PROJECT NAME: CHILDERS ROAD SUBDIVISION
 DRAWING TITLE: ZONING PLAN
 PROJECT NO: Z-01
 W&A PROJ. NO: 20143003.00.AT

PETITION NO.: Z-17

Z-17

ZONING COMMENTS:

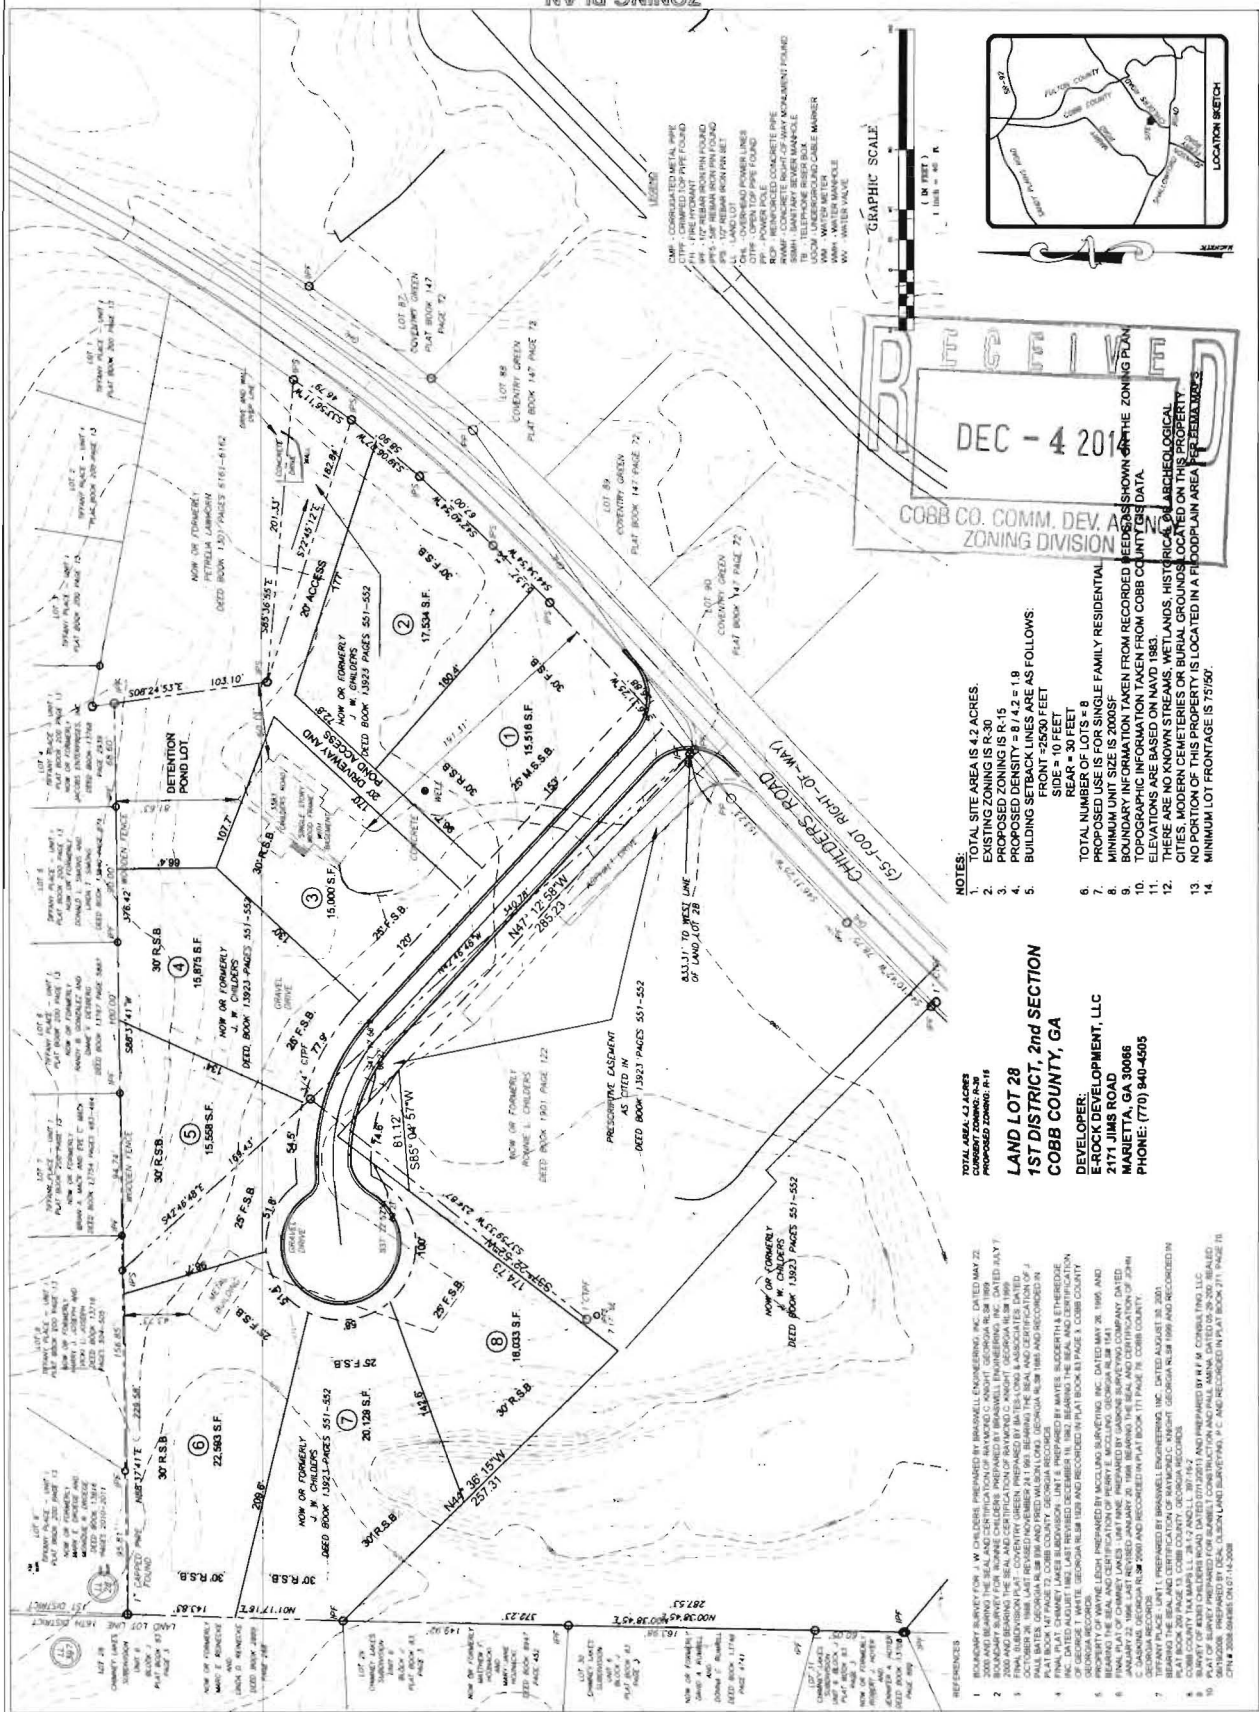
- No Stormwater controls shown _____
- Copy of survey is not current – Additional comments may be forthcoming when current site conditions are exposed.
- No site improvements showing on exhibit.

1. This site is located just northwest of Childers Road. Average slopes are relatively flat to moderate with maximum of 15%. The site cover is a mixture of open and wooded areas. The majority of the site (2/3) drains to the north into Tiffany Place Subdivision. The rear third drains into the Chimney Lakes Subdivision.
2. The detention facility must be tied directly to the existing downstream system within Tiffany Place S/D (Lot 4). The current channel conveyance through this lot does not have adequate capacity to handle the proposed increased runoff volume.
3. The majority of lots 6-8 will naturally bypass the detention pond. A drainage easement will be required at the rear of lots 4-6 to convey site runoff to the pond. Grading or landscape walls will likely be required to direct all impervious lot runoff to this easement.
